ADDENDUM TO THE CONTRACT DOCUMENTS

ADDENDUM No.: 2

DATE : 8/31/15

PROJECT: New Town Hall
Construction Project
26 Court Street
Plymouth, MA

POST PHASE I SITE GRADING PLAN

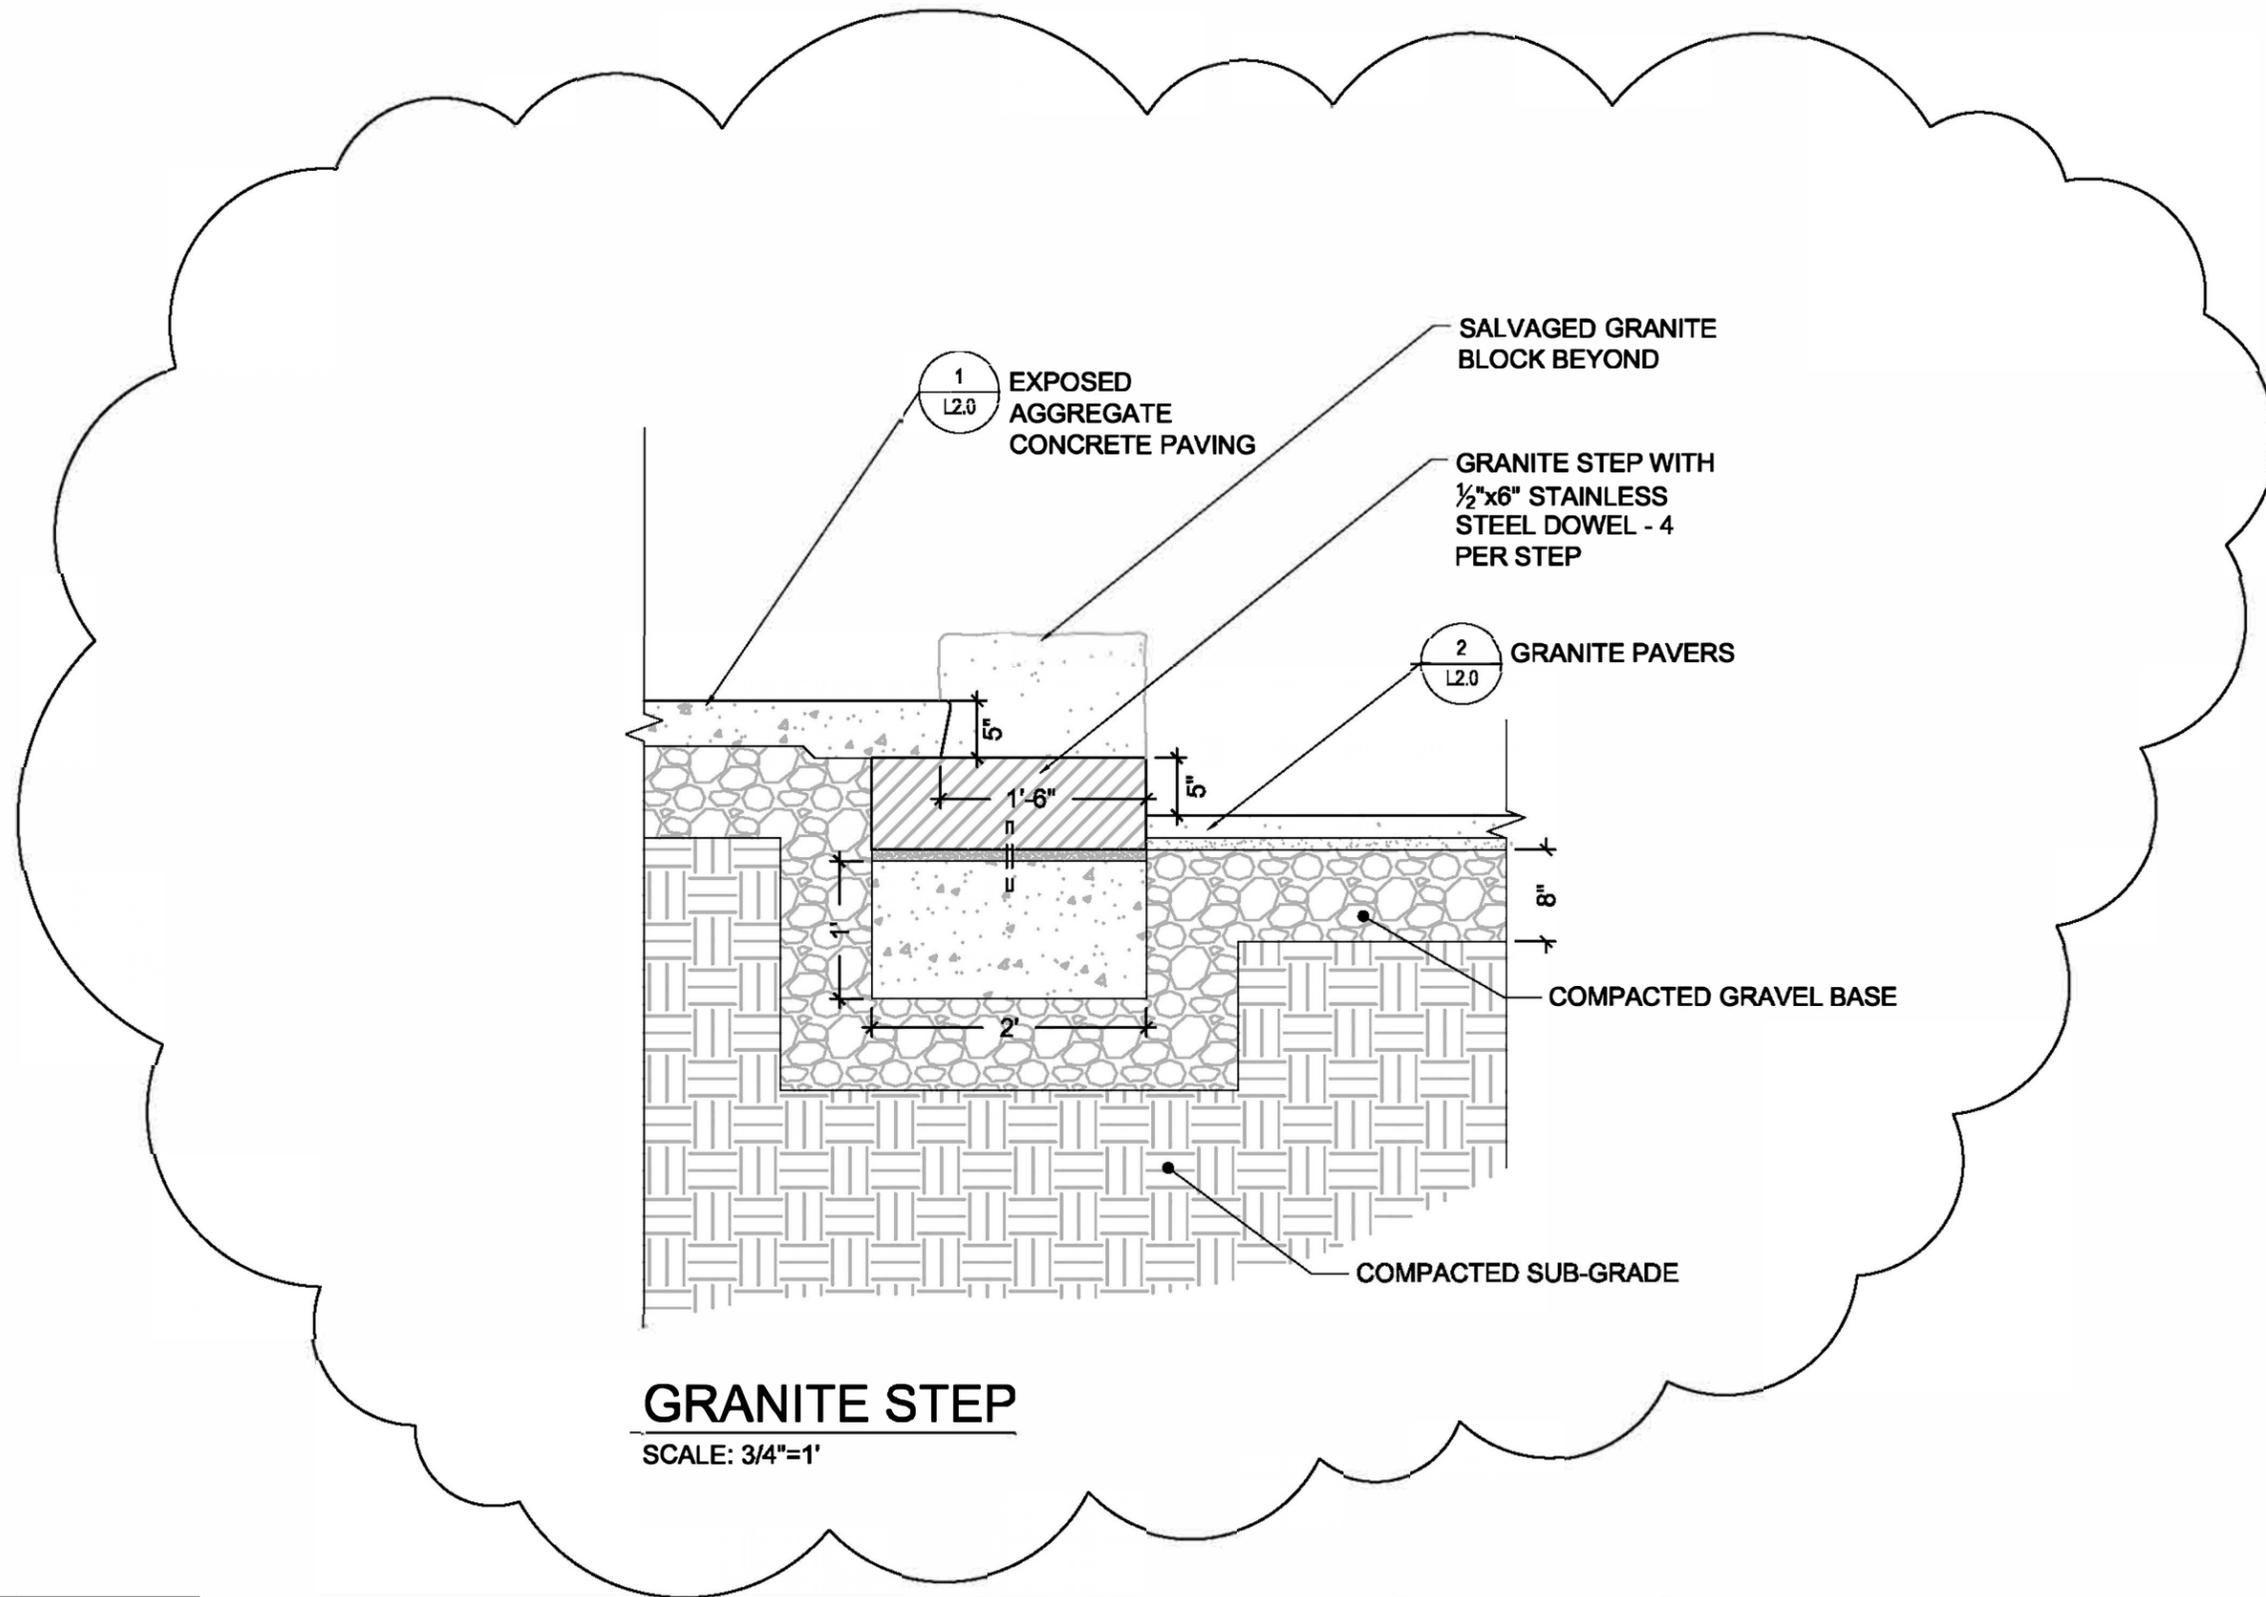
Drawing No.:	Description:
Civil	
C-10	Replace this drawing in its entirety with the attached revised C-10 drawing sheet.

GRANITE STEP AT RUSSELL ST. PLAZA

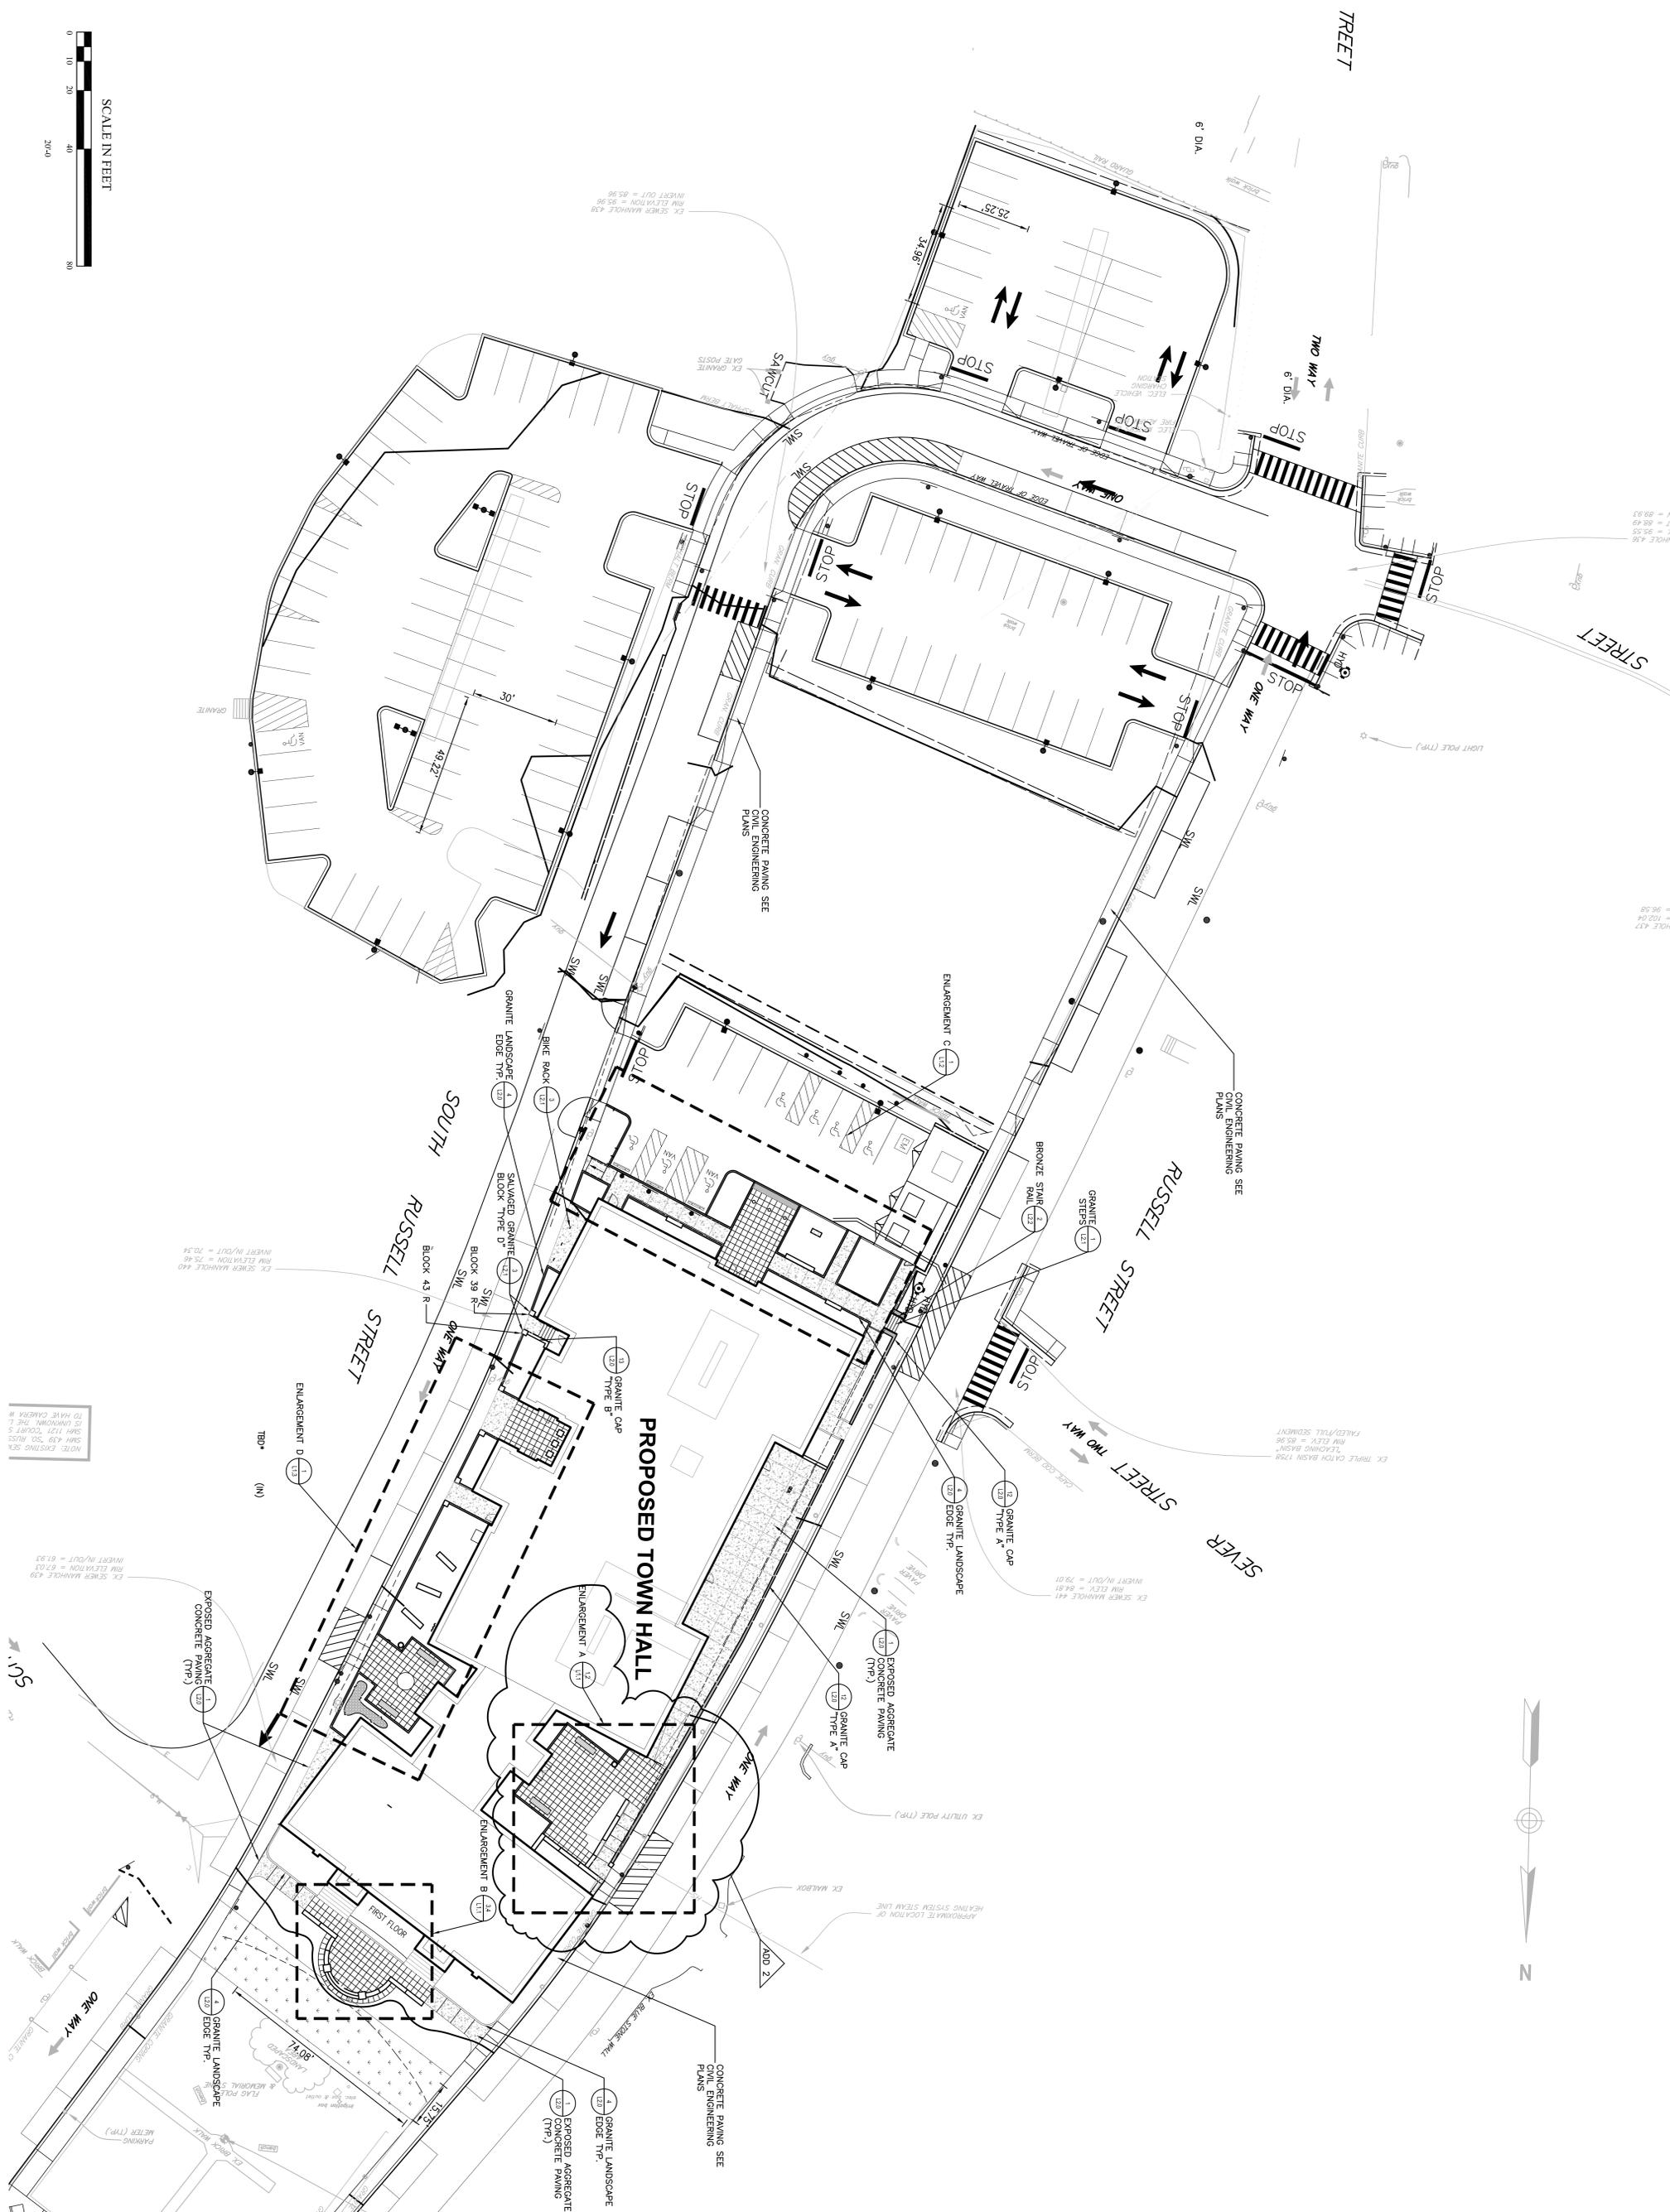
Drawing No.:	Description:
Landscape	
L1.0	1. Replace the drawing in its entirety with the attached revised sheet. a. Modifications have been made to the Russell Street plaza.
L1.1	1. Replace the drawing in its entirety with the attached revised sheet. a. Enlargement Area A – Layout and Dimension Plan: Modifications have been made to the layout and location of the sloped walkway and addition of a granite step. b. Enlargement Area A - Grading Plan: Modifications of grading have been made to accommodate the new sloped walk and step layout. c. Notes have also been modified to include requirement for shop drawings of salvaged granite walls.
L2.1	Omit details #3,4, 5 and 6. (Details are marked N.I.C.)
L2.2	1. Add "Granite Step Detail" at the Russell Street plaza as shown on attached sketch SKL-001.
L3.0	1. Replace the drawing in its entirety with the attached revised sheet. a. Plant list quantities have been modified. b. Plantings at the South Russell Street and Russell Street plazas have been modified. c. Plantings adjacent to the dumpster enclosure have been eliminated. d. Graphic scale has been modified to reflect the correct scale.

BASEMENT PLAN PLUMBING

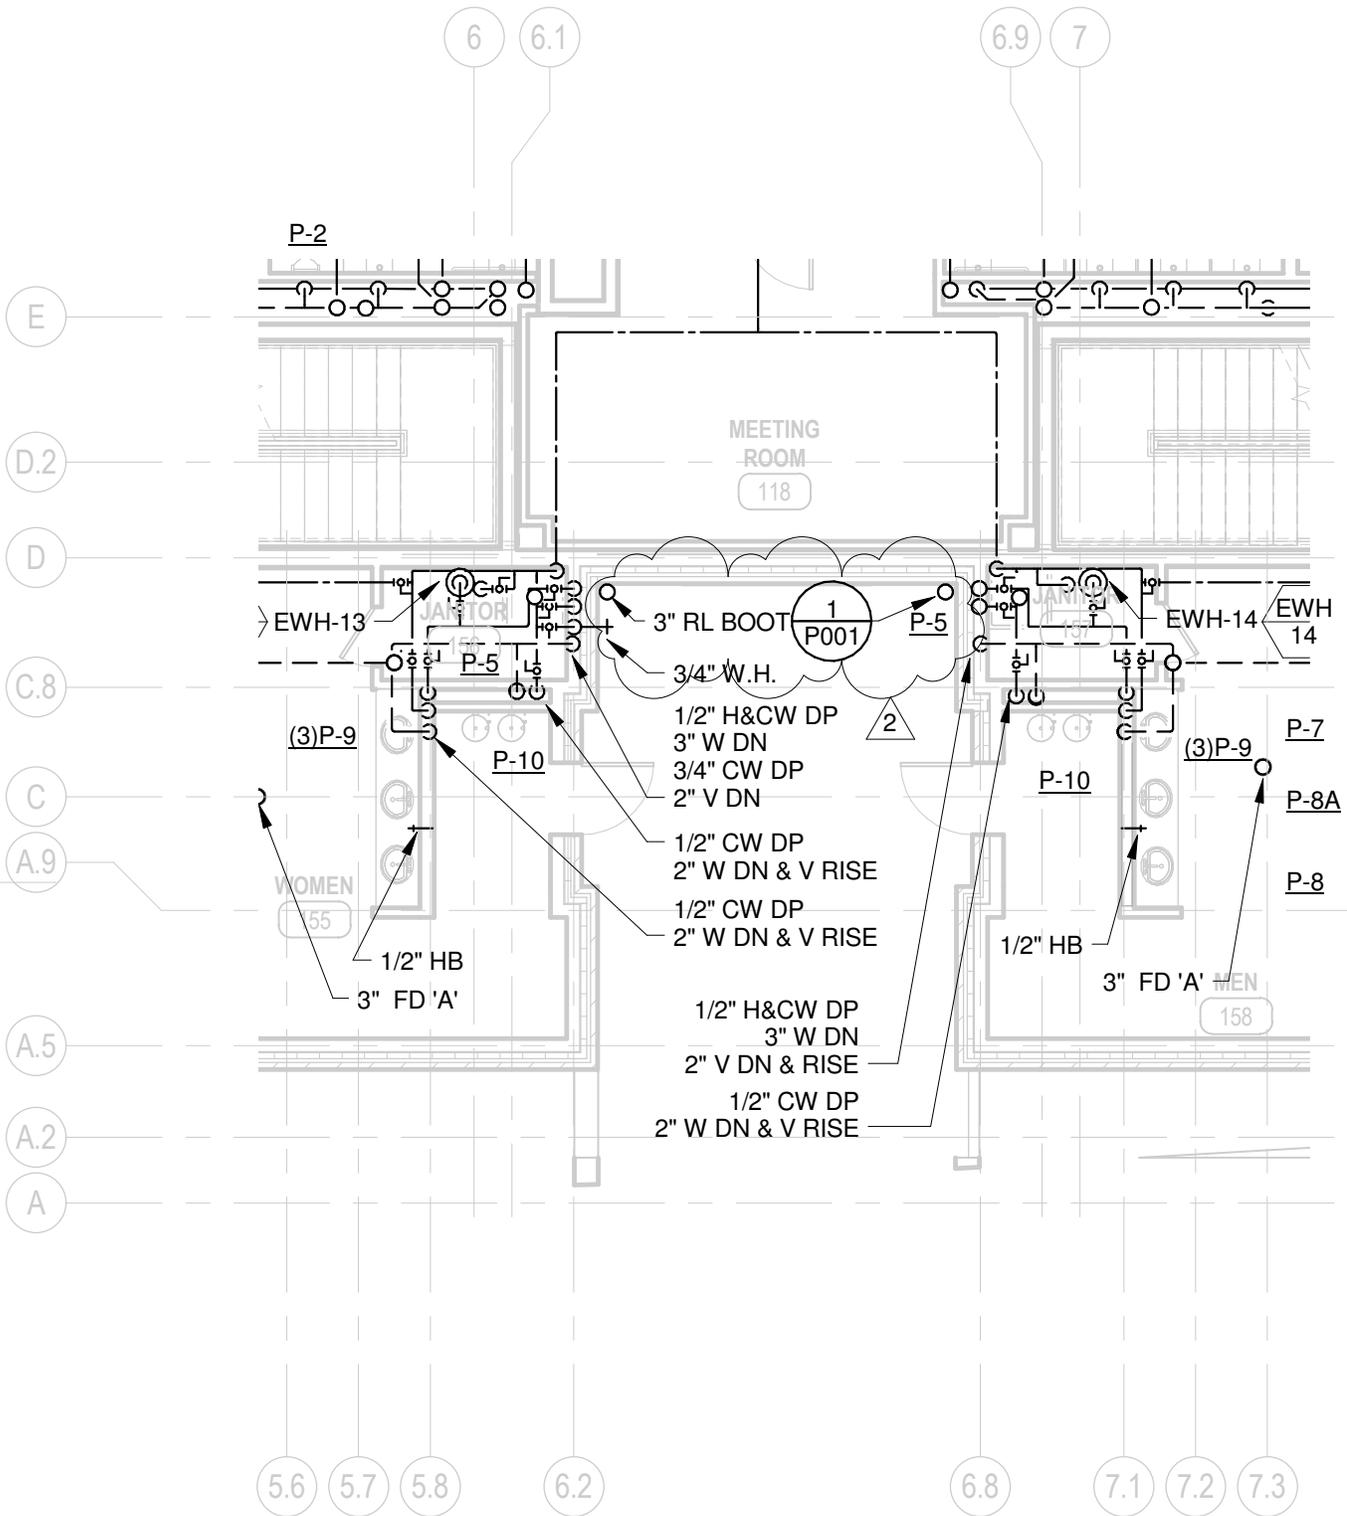
Drawing No.:	Description:
Plumbing	
P201	1. Below Slab Rain Leader piping revisions for Public Toilet Rooms; refer to sketch SKP001. 2. Rain Leader piping revisions for Public Toilet Rooms, Refer to sketch SKP002.
